## **Comments after November 4<sup>th</sup> Meeting – All In Support.**

Ref: 7 Van Buren Planned Development

## Drivers entering the alley won't see vehicles adequately

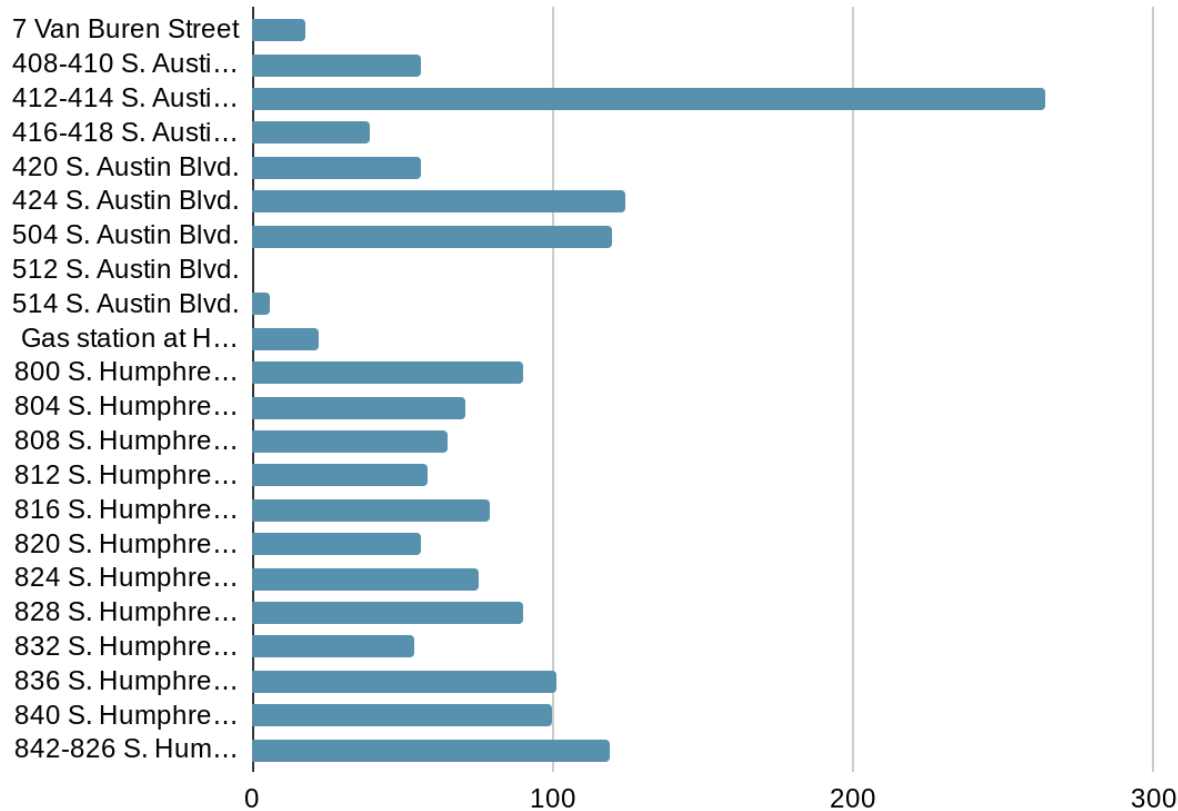
The "garage door" of this structure was located exactly per the Petitioners architectural plans and to the exact dimensions. The cardboard sheets represent the walls and the opening the garage door in this photo. A vehicle has to extend 6-7 feet out beyond the door in order to have visibility of the alleyway and any oncoming vehicles.

# MORE Visibility Issues- Potential for Collisions with only 1.5' setback

With the vehicle in the middle of the “garage door” this was the level of visibility available to the driver when projected out 6-7 feet. Please note that even at this point there is still not full visibility for the driver looking northbound up the alleyway - i.e. can not see any vehicle headed southbound from the alley beyond 700 block of South Humphrey Ave.

# Getting In & Out

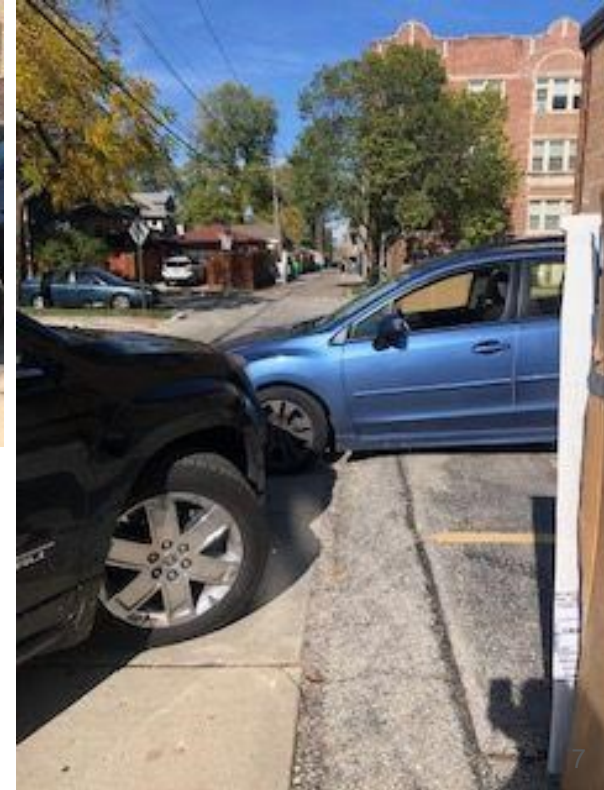
The Petitioner's Application states that available parking would allow two way traffic within the building. The door is 16 feet wide. This is problematic. In these photos we recreated the garage per the exact dimensions and placement of the architectural plans. The blue car is over as far as possible as close to the "garage door" <sup>6</sup>

## Drivers entering the alley won't see vehicles adequately

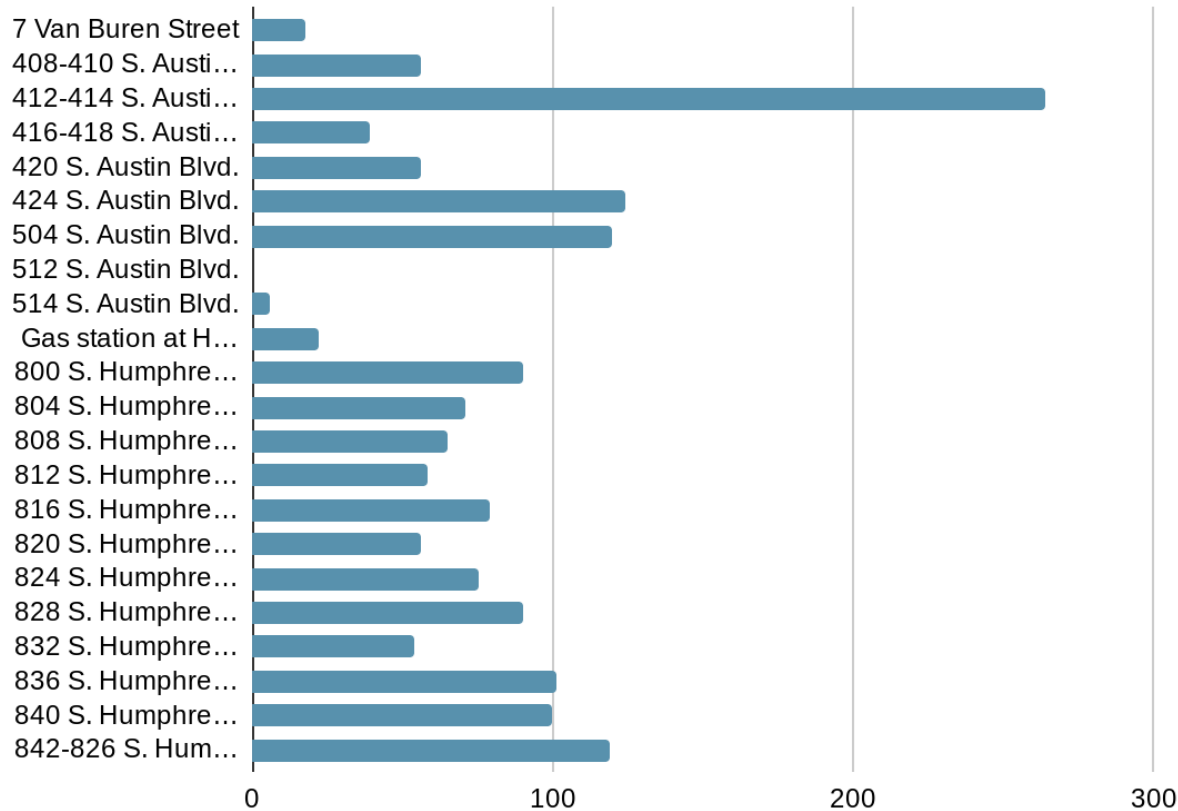
The "garage door" of this structure was located exactly per the Petitioners architectural plans and to the exact dimensions. The cardboard sheets represent the walls and the opening the garage door in this photo. A vehicle has to extend 6-7 feet out beyond the door in order to have visibility of the alleyway and any oncoming vehicles.

# MORE Visibility Issues- Potential for Collisions with only 1.5' setback

With the vehicle in the middle of the “garage door” this was the level of visibility available to the driver when projected out 6-7 feet. Please note that even at this point there is still not full visibility for the driver looking northbound up the alleyway - i.e. can not see any vehicle headed southbound from the alley beyond 700 block of South Humphrey Ave.

# Getting In & Out

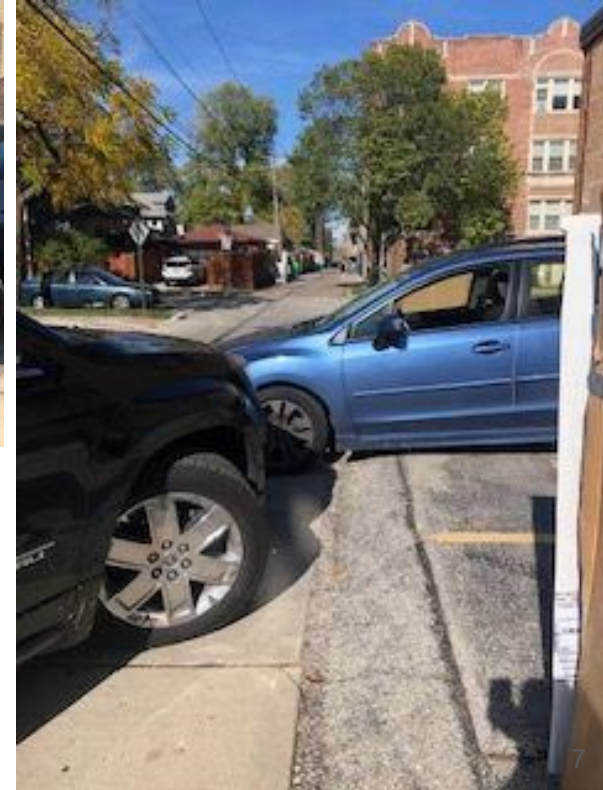
The Petitioner's Application states that available parking would allow two way traffic within the building. The door is 16 feet wide. This is problematic. In these photos we recreated the garage per the exact dimensions and placement of the architectural plans. The blue car is over as far as possible as close to the "garage door" <sup>6</sup>

Figure 1. 300-400 S. Austin Blvd. Streetscape (Ware Malcomb, September 14, 2021, included in Rescorp Application, p. 204)

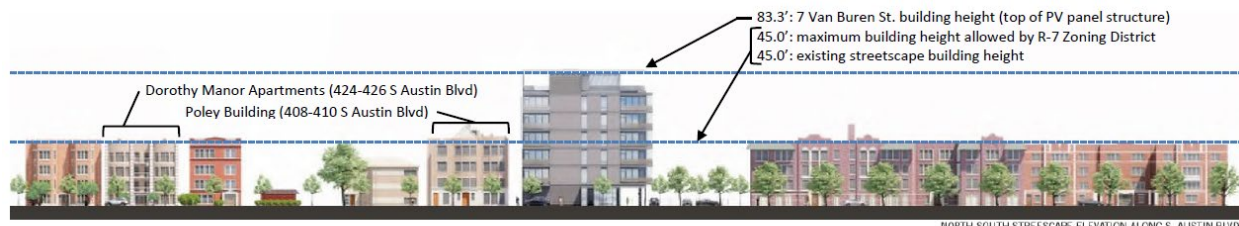
'Scale' refers to how we perceive the size of objects relative to other objects. Our sense of scale determines whether a building is of appropriate scale and proportion in the context of the immediate streetscape. As shown by Figure 1, the proposed building height and massing of the proposed building is significantly out of scale with the adjacent streetscape of the 300-400 blocks of S. Austin Blvd. In fact, the proposed building height of 83.3' (including PV panel structure) is 38.3' (85%) higher than the existing streetscape and R-7 Zoning District. Since the PV panels are part of a permanent structure that covers the entire expanse of the building, the building height is considered to be top of PV panels.
